INLET MANIFOLD GASKET - COOLANT LEAK

Bulletin Number - 0002

Date - 20.01.1999

Model - Freelander

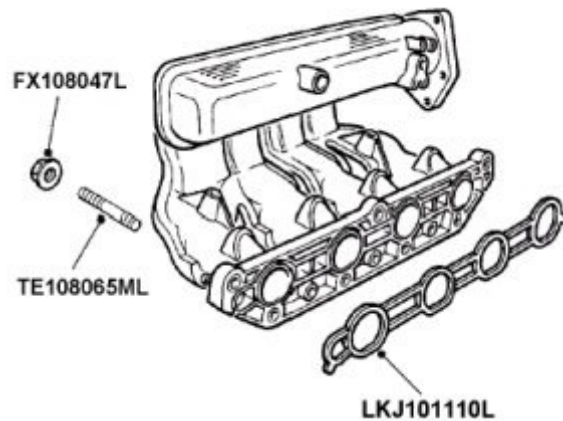
- Relaxation of inlet manifold fixings resulting in external or internal coolant loss.
 - Distorted / damaged inlet manifold gasket due to overheating.

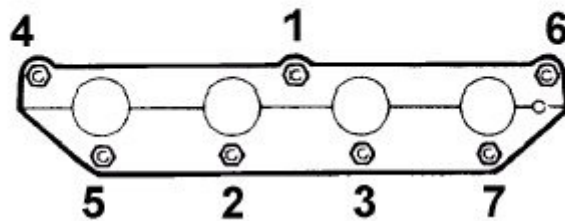
5. Tighten all manifold nuts to 17 Nm in the sequence shown in illustration.

17 Nm

1. Remove old type (black) inlet manifold gasket.
2. Remove the 3 upper manifold studs.
3. Fit 7 new type 'patchlock' studs, part number TE108065ML to all inlet manifold threaded holes.

NOTE: Patchlock stud end must be fitted to cylinder head.

4. Refit manifold with modified (green) gasket, part number LKJ101110L and modified fixing torque nuts FX108047L.
